**SUBJECT:** Submittal of Second Updates to NuScale Power, LLC Standard Plant Design Certification Application, Revision 4

Enclosure: Second Updates to NuScale Power, LLC Standard Plant Design Certification Application, Revision 4

Second Updates to NuScale Power, LLC Standard Plant Design Certification Application,  
Revision 4

Figure 7.1-1n: ESFAS Emergency Core Cooling System Actuation, Low Temperature Overpressure Protection Actuation

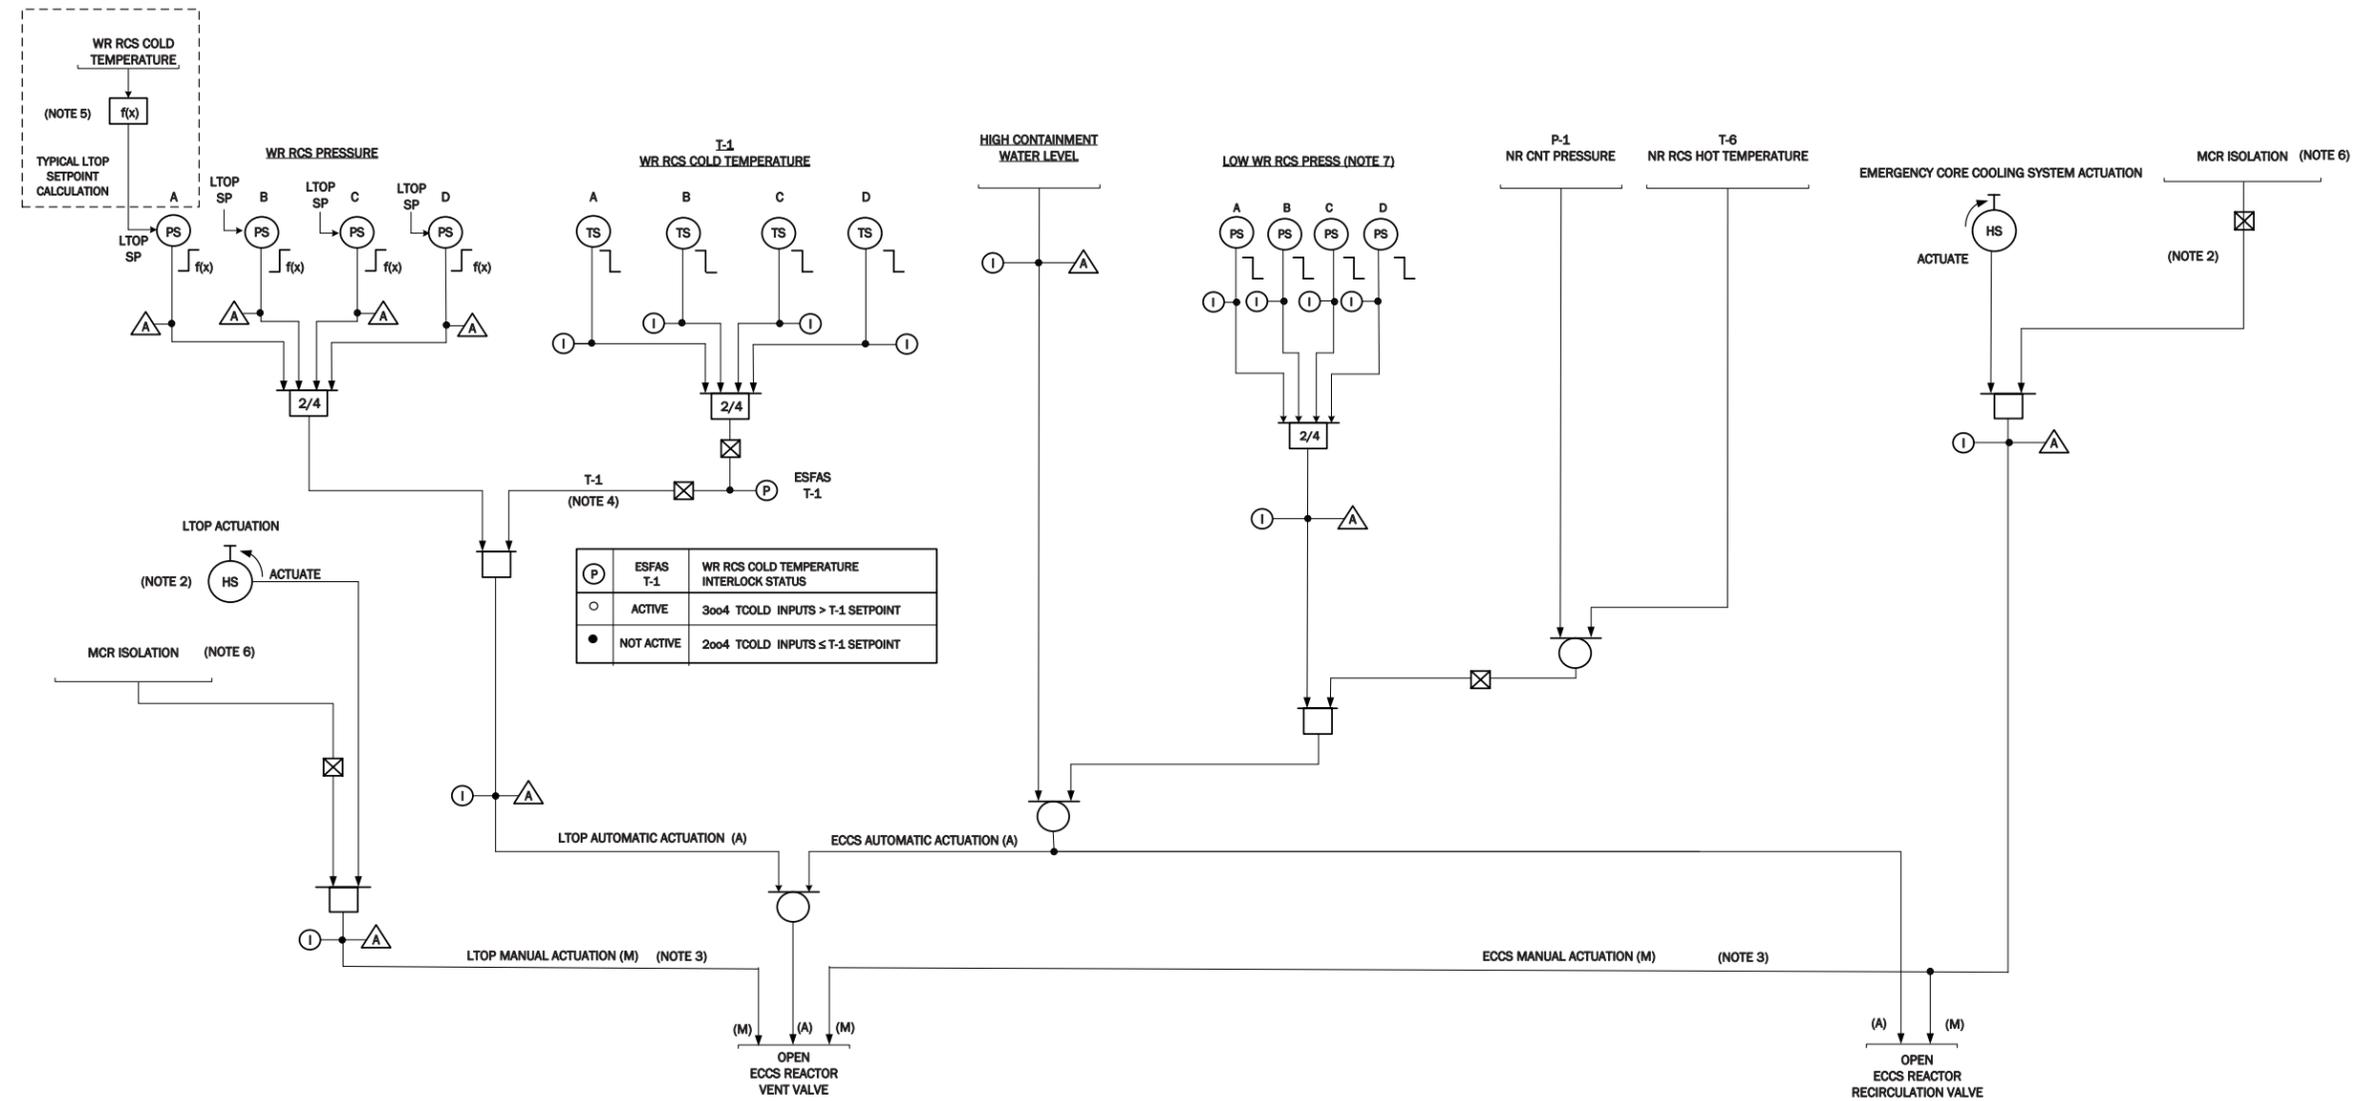
Module protection system (MPS) logic changes in FSAR Chapters 3, 6, and 7;

- NOTE 1: LOGIC IS SHOWN FOR DIVISION I ONLY. LOGIC FOR DIVISION II IS THE SAME AS DIVISION I.
- NOTE 2: TWO SWITCHES, ONE PER ESFAS DIVISION.
- NOTE 3: MANUAL ACTUATE INITIATES LTOP ACTUATION AND EMERGENCY CORE COOLING SYSTEM ACTUATION AT THE DIVISION LEVEL THROUGH THE EIM APL LOGIC.
- NOTE 4: LOW TEMPERATURE INTERLOCK T-1: AUTOMATIC BLOCK ABOVE T-1; AUTOMATIC LTOP ENABLE BELOW T-1.
- NOTE 5: LTOP SETPOINT (SP) IS CALCULATED BASED ON WR RCS COLD TEMPERATURE. LTOP ACTUATION OCCURS WHEN 2/4 WR RCS PRESSURE INPUTS INCREASE ABOVE THE LTOP SP. (REFERENCE 3)
- NOTE 6: TWO MANUAL ACTUATION ISOLATION SIGNALS, ONE PER RTS/ESFAS DIVISION.
- NOTE 7: IF NR CONTAINMENT PRESSURE INTERLOCK P-1 IS ACTIVE OR NR RCS THOT INTERLOCK T-6 IS ACTIVE, THEN A BYPASS IS ACTIVE FOR ECCS ACTUATION ON LOW RCS PRESSURE.
